Kevin Murphy
4508 Murphy Rd
Knoxville TN 37918

RE: [5-G-21-UR](#), indoor self storage facility on Middlebrook Pike

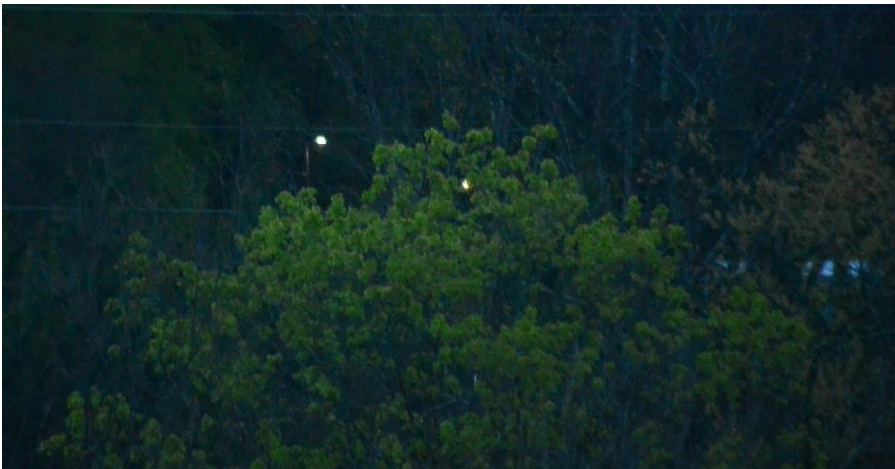
2. The wall packs on the sides of a metal building will cast a lot of glare out, which defeats the purpose of fully shielded lights. Building cladding directly under wall scones should be a dark, non-reflective material. Please see the below picture of a self storage building built next to me and how the wall

scones shine brightly.

I request that staff and commission consider adding conditions that for sides facing and visible from adjacent residences, house-side shields be required for free-standing luminaires and that the building material beneath wall scones be a non-reflective, dark material to reduce or eliminate the glare from the wall scone cast the wall.
